Regulation No. 17 strength of seats. Request for clarification

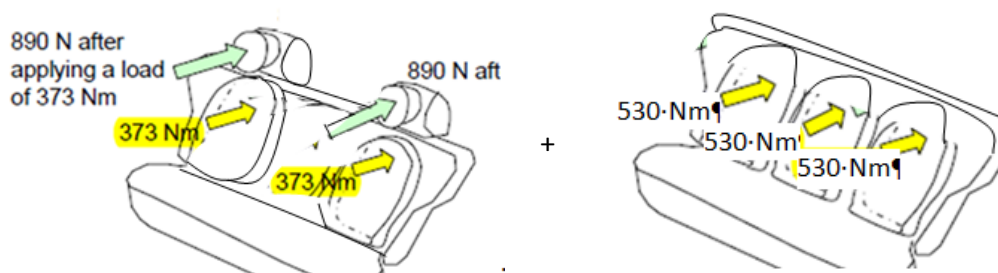
- A. The head restraint performance test of 6.4. is conducted simultaneously on the 2 outboard seating positions and no load is added in the center seat. In addition the seat back strength test of 6.2. is performed simultaneously in all 3 seating positions.

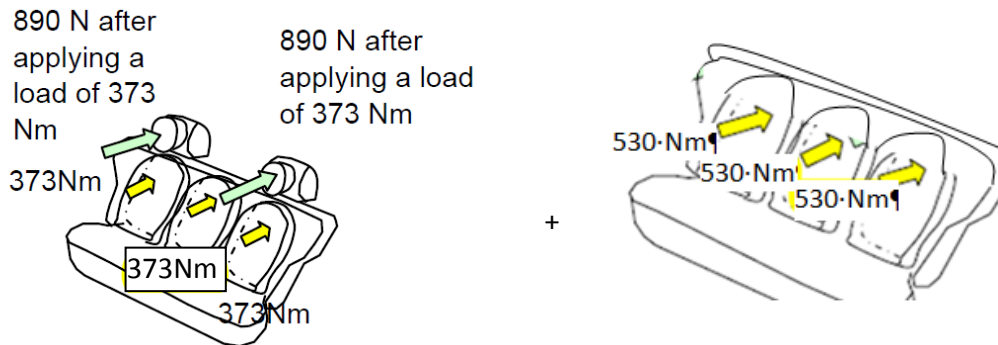
B. The head restraint performance test of 6.4. is conducted on the 2 outboard seating positions and a load of 373Nm is added in the center seating position. In addition the seat back strength test of 6.2. is performed simultaneously in all 3 seating positions.

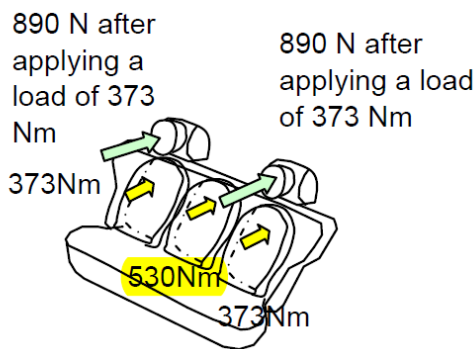
C. The head restraint performance test of 6.4. is conducted on the 2 outboard seating positions and a load of 530Nm is added in the center seating position. The seat back strength test of 6.2. is not anymore requested.
